**ADDENDUM #1
Public Works
2021 Boulder County Bridge Rails and Signal Poles Painting (Project No. BM-21-00)
BID # 7249-21**

August 3, 2021

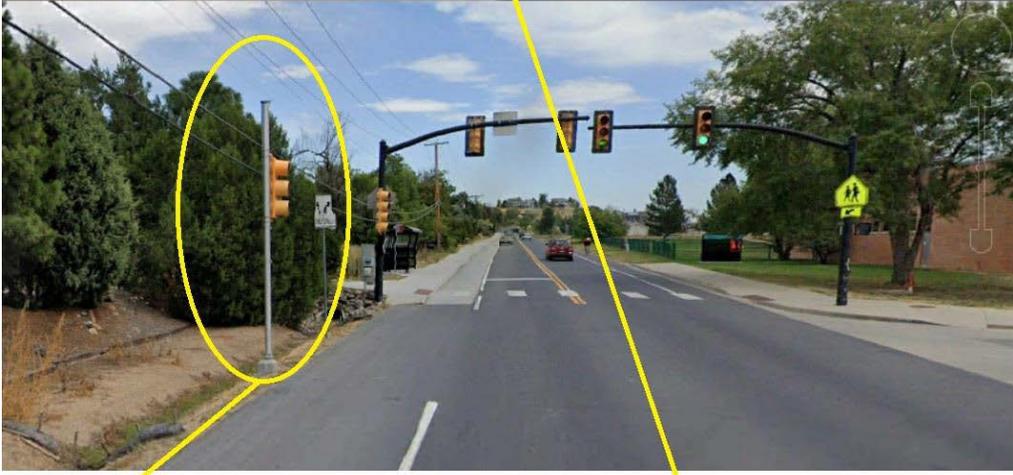
19. Question: Can you please confirm that the areas of the poles and arms being painted are for the vertical shaft and horizontal arms only, and that it does NOT include any signal heads, ped heads or mounting hardware? (See picture below for some examples).

Tree to be trimmed by others?

Signal heads to be protected and not painted?

ANSWER: Confirmed. The areas of the poles and arms being painted are for the vertical shaft and horizontal arms only and do NOT include signal heads, ped heads or mounting hardware.

Trees affecting the contractor's access to paint the signal poles will not be trimmed by others. Instead, the contractor should plan to trim the trees at his/her expense. Payment for tree trimming will not be separate, but will be included in the cost of the work.
